Transportation of leakage and deformed fuels to  
the common pool from the spent fuel pool  
at Unit 4, Fukushima Daiichi Nuclear Power Station

July 31, 2014

Tokyo Electric Power Company

# 1. Application for changes in the implementation plan

NFT-12B Figure

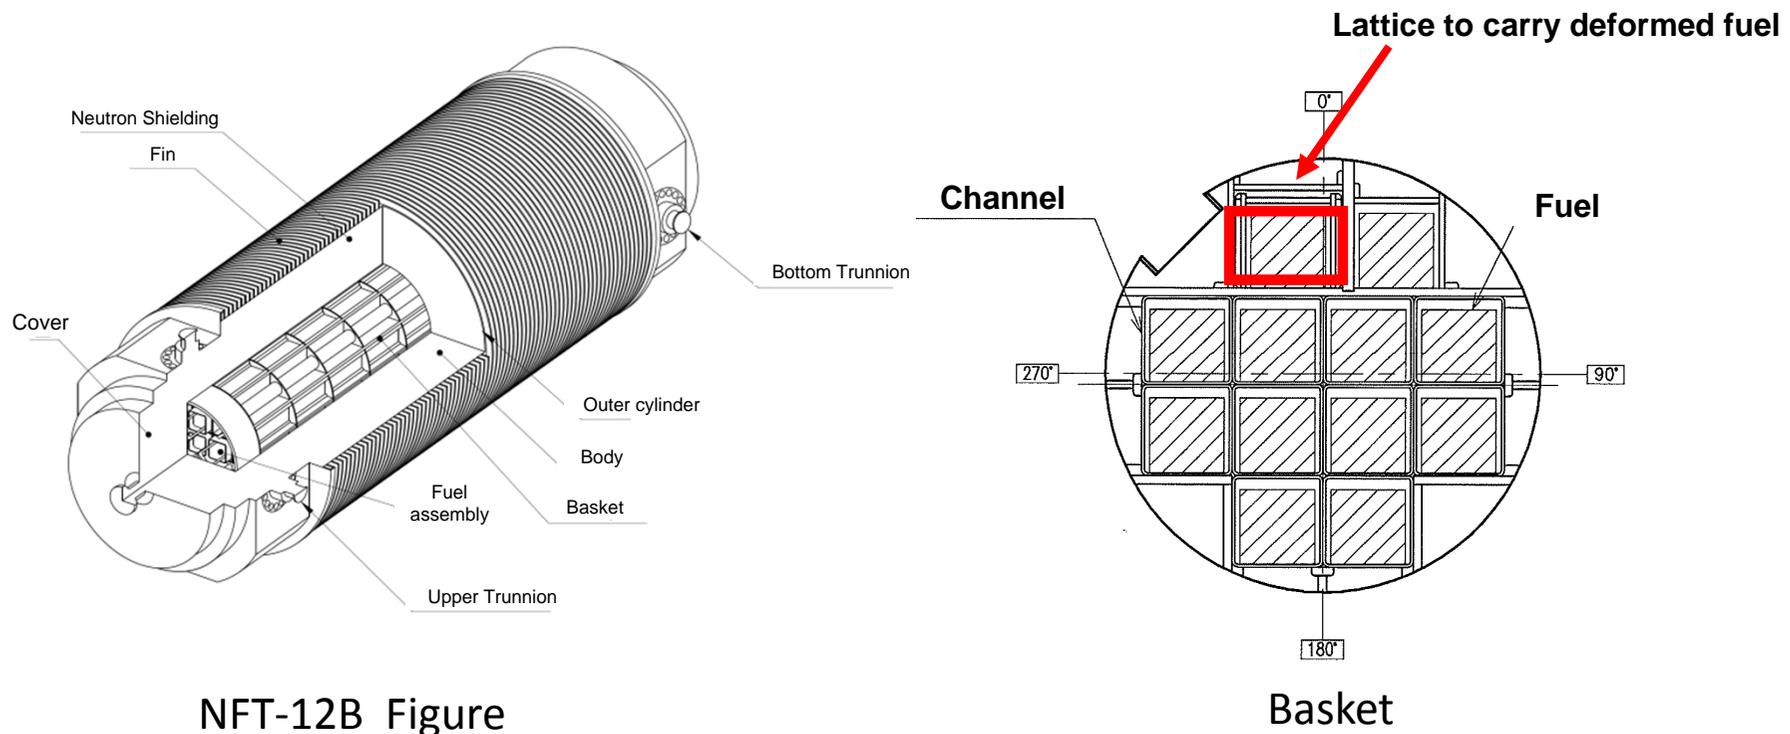
■ For the transportation of leakage and deformed fuels, the existing container, NFT-12B model (12 fuels capacity), is to be used.

- ✓ Deformed fuel is to be transferred by being placed in the biggest lattice (in diameter) in the basket.
- ✓ Leakage fuels are to be transferred by being placed in other lattices in normal size in the basket,.
- ✓ Fine fuels are also to be transferred by being placed in the same basket together with both deformed and leakage fuels.
- ✓ A safety evaluation such as subcriticality evaluation is to be conducted newly, assuming pellets scattering off of a fuel rod during the transfer of these leakage and deformed fuels.
